UNITED STATES PATENT AND TRADEMARK OFFICE

APPLICATION NO.	FILING DATE	FIRST NAMED INVENTOR	ATTORNEY DOCKET NO.	CONFIRMATION NO.
09/704,028	11/01/2000	Gary G. Lenihan	060545/0456	2436

Office Action Summary

DETAILED ACTION

Fig
(9)

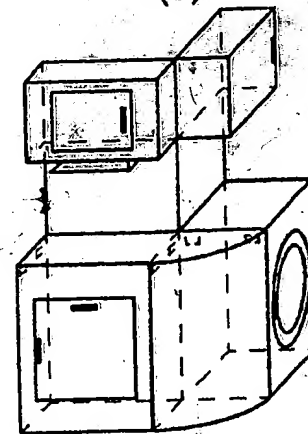
Klien teaches in figures 1-8 a toy kitchen comprising a main unit (marked copy fig.9) and a repositionable island (marked copy fig. 9) removably coupled to a front surface of the main unit (marked copy fig. 11) to form at least two separate play areas (marked copy fig. 11).

Regarding claim 2, as best understood, Klien further teaches removably attached to the main unit in one of at least three positions (fig. 9 and fig. 11).

Regarding claim 17, Klien further teaches the first unit removably positioned to the second the second unit in at least the first and second positions (fig 9 and 11).

Fig
(11)

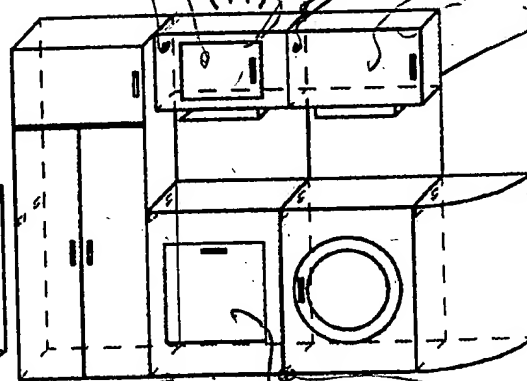
Regarding claim 6, Klien further teaches the island is removably connected to the left side of the main unit (fig. 11) to form a continuous play area along a single plane.

Regarding claim 12, Klien teaches in figures 1-8 a repositionable toy kitchen comprising a first unit extending along a first vertical longitudinal plane (marked copy fig. 11), at least one removable and repositionable second unit extending along a second vertical longitudinal plane (marked copy fig. 11), the second unit removably connected to a front surface of the first unit to form at least two play areas (marked copy fig. 11, "play area") and the second position, where the first and second planes are coplanar (fig. 11).

Regarding claim 13, as best understood, Klien further teaches first and second play areas (marked copy fig. 11 "first and second play areas"; notice the examiner considers the space indicated by "second play area" behind the first unit and the space

indicated by "first play area" to be the play areas), the first and second play areas bounded by the one side of the first unit (As best understood, the examiner considers the first and second areas to be bounded by the sides where the first and second unit meet as seen in marked copy fig. 11, "bounded"), and the second position defines a continuous play area extending along of the second unit (fig.11).

FIG 10

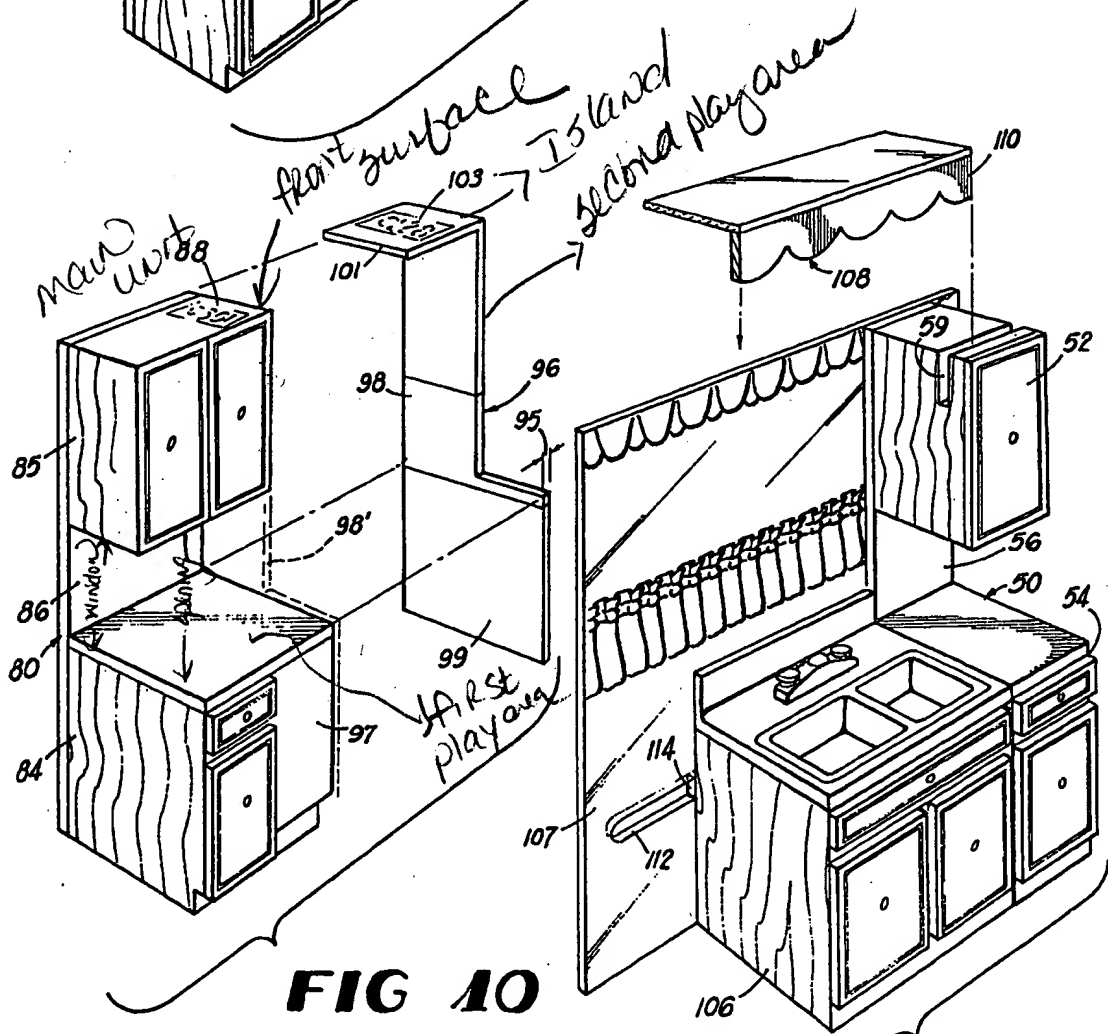
McKee teaches in figures 1-13 a toy kitchen comprising a main unit (marked copy fig. 10) and a repositionable island (marked copy fig. 10) removably coupled to a front surface of the main unit (marked copy fig. 10) to form at least two separate play areas (marked copy fig. 10).

Regarding claim 9, as best as understood, McKee further teaches a front and rear side (fig. 10), an opening defined within the main unit extending from the front side to the rear side (marked copy fig. 10) and the main unit comprising a window at the opening (marked copy fig. 10).
